<b>Title - Sujet</b> Fire Suppression System&Fire Alarm Fire Suppression System and Fire Alarm Replacement	
<b>Solicitation No. - N° de l'invitation</b> EP076-201304/A	<b>Amendment No. - N° modif.</b> 014
<b>Client Reference No. - N° de référence du client</b> 20201304	<b>Date</b> 2021-04-13
<b>GETS Reference No. - N° de référence de SEAG</b> PW-\$\$\$FG-374-79676	
<b>File No. - N° de dossier</b> fg374.EP076-201304	<b>CCC No./N° CCC - FMS No./N° VME</b>
<b>Solicitation Closes - L'invitation prend fin</b> <b>at - à 02:00 PM</b> Eastern Daylight Saving Time EDT <b>on - le 2021-04-13</b> Heure Avancée de l'Est HAE	
<b>F.O.B. - F.A.B.</b> <b>Plant-Usine:</b> <input type="checkbox"/> <b>Destination:</b> <input checked="" type="checkbox"/> <b>Other-Autre:</b> <input type="checkbox"/>	
<b>Address Enquiries to: - Adresser toutes questions à:</b> Vani-Machado, Alba	<b>Buyer Id - Id de l'acheteur</b> fg374

Amendment 014 is issued for the following:

T58 Building Fire Suppression System Questions  
Solicitation – EP076-201304

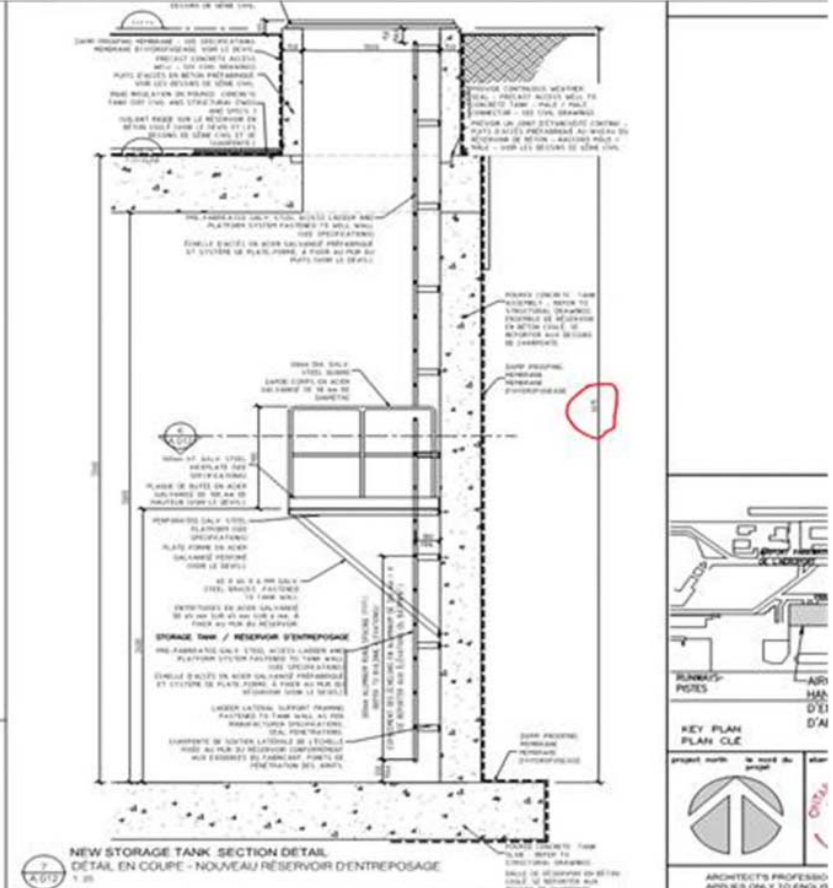
<div>5      Ensure that ducts, piping, equipment, or other items which would interfere with application of fireproofing are not positioned until fireproofing work is completed.</div> <div>3.3      APPLICATION</div> <div><div>1      Apply bonding adhesive or primer to substrate if recommended by manufacturer.</div><div>2      Apply fireproofing to correspond with tested assemblies, or acceptable calculation procedures to provide following fire resistance ratings.<table><tr><td>Location</td><td>Rating</td><td>ULC Rating</td></tr><tr><td>Roof decks</td><td>2 hour</td><td>ULC BXUVC.F816</td></tr></table></div><div>3      Apply fireproofing over substrate, building up to required thickness to cover substrate with monolithic blanket of uniform density and texture.</div><div>4      Apply fireproofing directly to open web joists without use of expanded lath.</div></div>	Location	Rating	ULC Rating	Roof decks	2 hour	ULC BXUVC.F816	<div>3.3.8 of Section 07 81 00 apply where exiting fireproofing is disturbed. See addendum for fireproofing at new building.</div>
Location	Rating	ULC Rating					
Roof decks	2 hour	ULC BXUVC.F816					
<div>Q 14 - Please provide missing specification section# 03 35 10 for concrete floor finishing.</div>	<div>A 14 – Reference to Section 03 35 10 within section 09 67 23 will be deleted via addendum. Floor finishing requirements for epoxy flooring to be in accordance with 03 30 00 Cast in Place Concrete and manufacturers requirements.</div>						
<div>Q 15 - Section 3.6 in painting specification section# 09 91 23 indicates the requirement to paint finished area exposed conduits, piping, hangers, etc. as indicates in section below. Please confirm if this work is required? and if so please clarify extent?</div> <div>3.6      MECHANICAL/ELECTRICAL EQUIPMENT</div> <div><div>1      Paint finished area exposed conduits, piping, hangers, ductwork and other mechanical and electrical equipment with colour and finish to match adjacent surfaces, where indicated.</div><div>2      Other unfinished areas: leave exposed conduits, piping, hangers, ductwork, and other mechanical and electrical equipment in original finish and touch up scratches and marks.</div><div>3      Touch up scratches and marks on factory painted finishes and equipment with paint as supplied by manufacturer of equipment.</div><div>4      Do not paint over nameplates.</div><div>5      Keep sprinkler heads free of paint.</div><div>6      Paint fire protection piping.</div><div>7      Paint disconnect switches for fire alarm system and exit light systems in red enamel.</div><div>8      Paint natural gas piping.</div></div>	<div>A 15 - Refer to specific specification sections to determine extent of painting within hangar, such as, painting of foam and sprinkler piping within hangar, touch up of natural gas piping where project work affects. Addendum will be issued to clarify this specification section.</div>						
<div>Q 16 - What is the painting work to be carried out concerning the existing Part of the building? Also, please confirm if concrete walls and metal deck at new added valve room to be painted?</div>	<div>A 16 - Paint new concrete block at door infill to match adjacent walls. Clarification will be issued in addendum.</div>						
<div>Q 17 - Can you please confirm that the term Blastrac refers to a shot blaster Page A.001 from architectural drawing?</div>	<div>A 17 – All references to Blastrac may be read synonymously as shot blast. No addendum required.</div>						
<div>Q 18 - On the section A-A on the drawing S102, it shows that the inner walls verticals are 15M@250mm EW and 20M@200mm and 15M@300mm for the exterior walls; but there is also a note that says 20M@225mm verticals for inner walls and 20M@250mm for the exterior walls. Can you clarify me which note is right one for the walls or if both apply?</div>	<div>A 18 – section A-A/S102 has been revised, please refer to clouded areas on S102. Revised plan will be issued in addendum.</div>

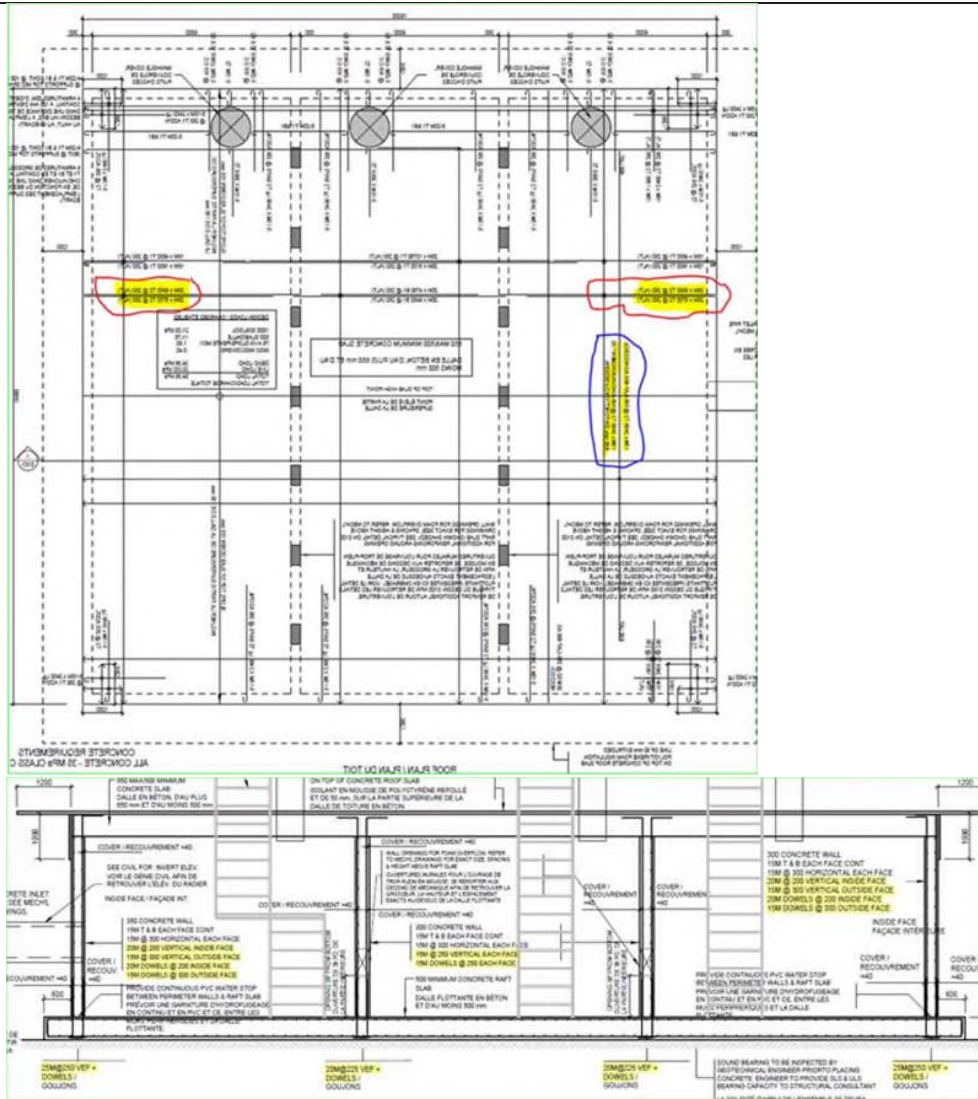
Q 30 - In drawing S102, section A-A/S101 – CROSS-SECTION, the wall reinforcement is shown on the side of each wall. Also bottom of each wall is shown vertical reinforcement which is different from the vertical reinforcement shown on the side of the walls. See section “A-A” below. Can you please clarify which vertical reinforcement should be used?	A 30 – We have revised our wall reinforcement in section A-A/S102, refer to clouded areas on S102 in addendum for further details.

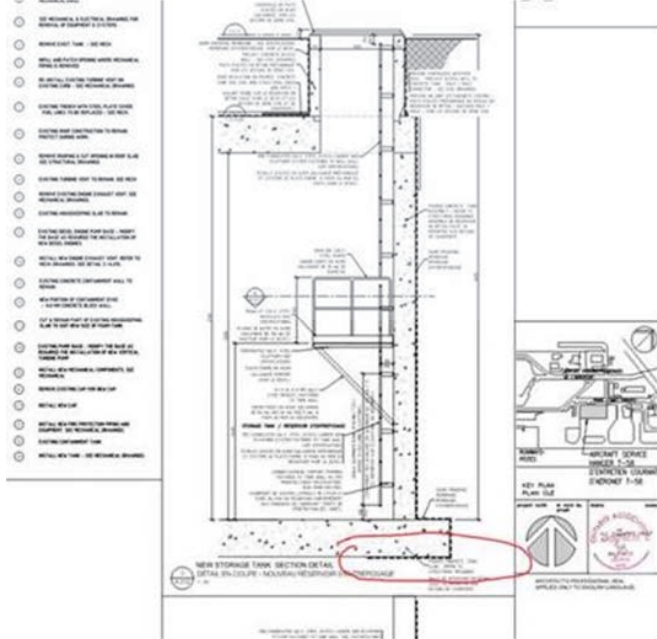
Q 32 - Detail 7/A.12 shows damp-proofing membrane extending under the tank footing. Please confirm if the damp-proofing membrane has to go around the whole tank (including

walls, above slab and under tank footing)?

A 32 – Dampproof membrane to stop at bottom of footing. Part of dampproof membrane under footing will be deleted in Addendum.

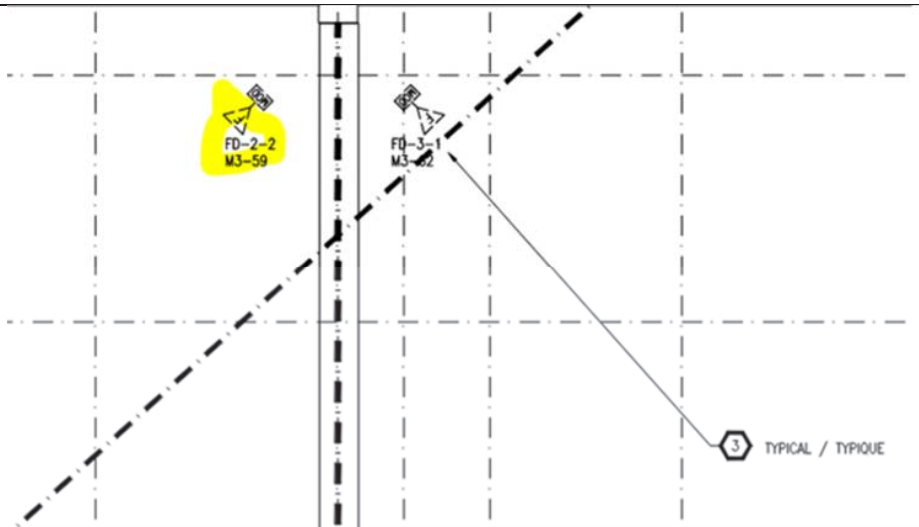
<p>Q 54 – When comparing dwg E303 (note 9) and E308 (note 3) as well as comparing E304 (note 8) and E309, I am unsure if the intent is to have 2 sets of flame sensors at the same location (one at 5M AFF, and one at 1.2M AFF). Please confirm.</p>  <p><b>9</b> TYPICAL FLAME SENSORS TO BE MOUNTED 1200mm A.F.F.</p> <p>This typical note isn't pointing to a device.</p> <p><b>E.308</b></p>

E.304

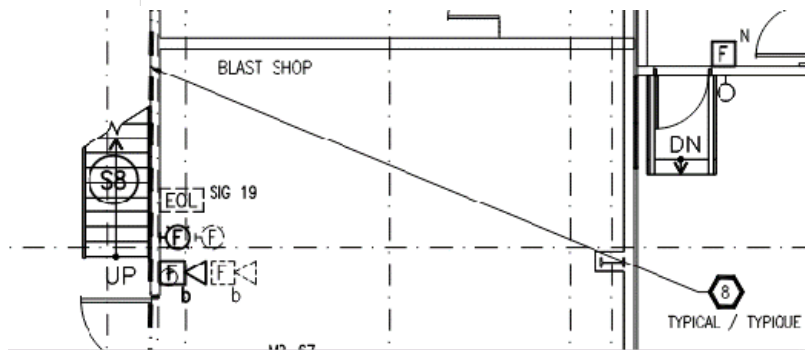
**8** TYPICAL  
FLAME SENSORS TO BE MOUNTED 1200mm A.F.F.

This typical note isn't pointing to a device.

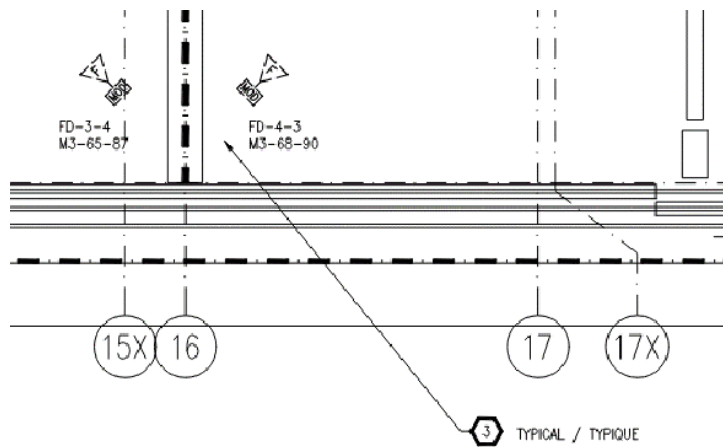
(is this the same as shown on E304, note 8?)

**3** TYPICAL  
REPLACE EXISTING FLAME DETECTOR AND ADDRESSABLE MODULE. EXISTING  
MOUNTING HEIGHT APPROXIMATELY 5 METERS A.F.F.

Q 55 - In regards to the flame detectors, can you confirm that all of the existing flame detectors shown are to be replaced with new? Typically existing fire alarm devices are shown on the drawings to be removed with new devices shown next to these, but for the flame detectors, only the existing ones are shown with a typical note to provide a new one.

A 55 – All flame detectors are to be replaced.

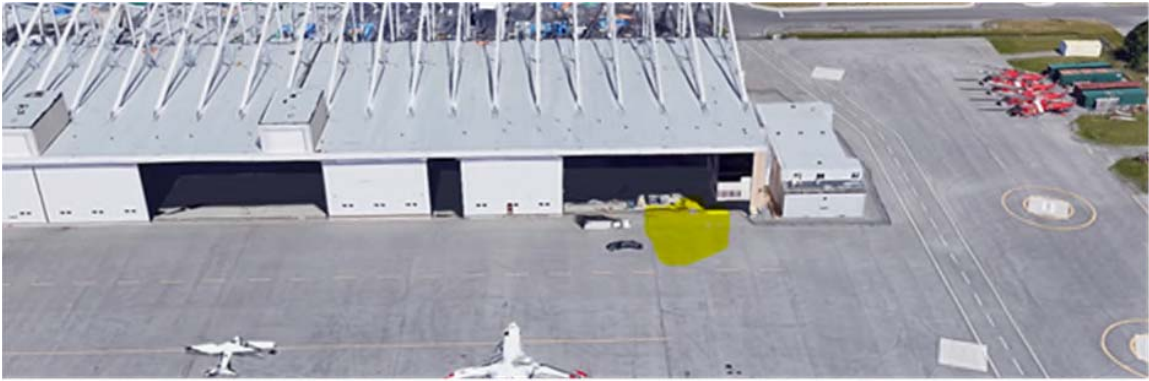
Q 61 - Regarding the preliminary test for the High Expansion foam Generator, in section 21 13 00.01, 3.4.1.3 asking to test each HEF generator individually, it will not be a good test for the whole system (as they are deluge system) and will not show some deficiencies like balancing of the system and time of discharge at the farthest HEF generator. Is the preliminary test can be a full test with water only, meaning that all the HEF generator will flow water simultaneously for a short period of time? Is the proportioners preliminary test can be done at a test port on the man riser and at the test headers?

A 61 – bid as per plans and specifications.
